## **DEER PORT COMMERCE PARK SUBDIVISION**

APPLICATION NUMBER 15 DATE June 19, 2003

REQUEST Subdivision

## DETAIL SITE PLAN

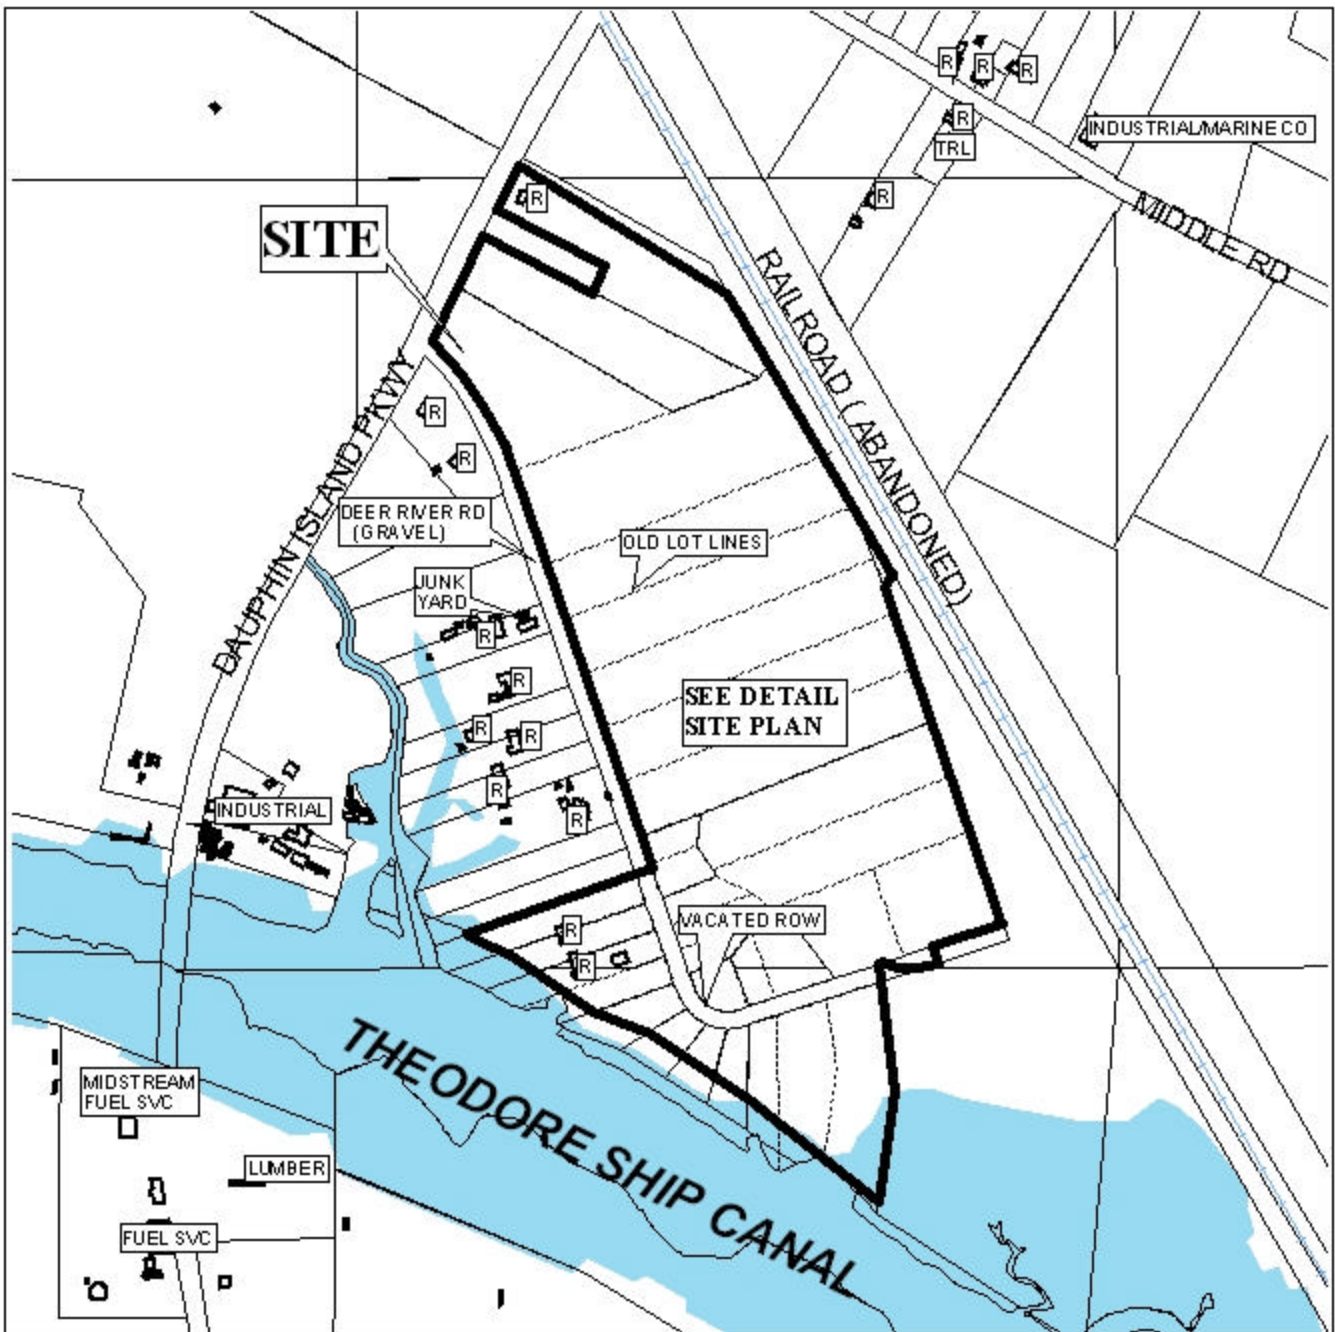
As illustrated on the Detail Site Plan, wetlands are prominent throughout the site, therefore, the area could be considered environmentally sensitive. Permits from all applicable federal, state and local agencies should be obtained prior to permitting.
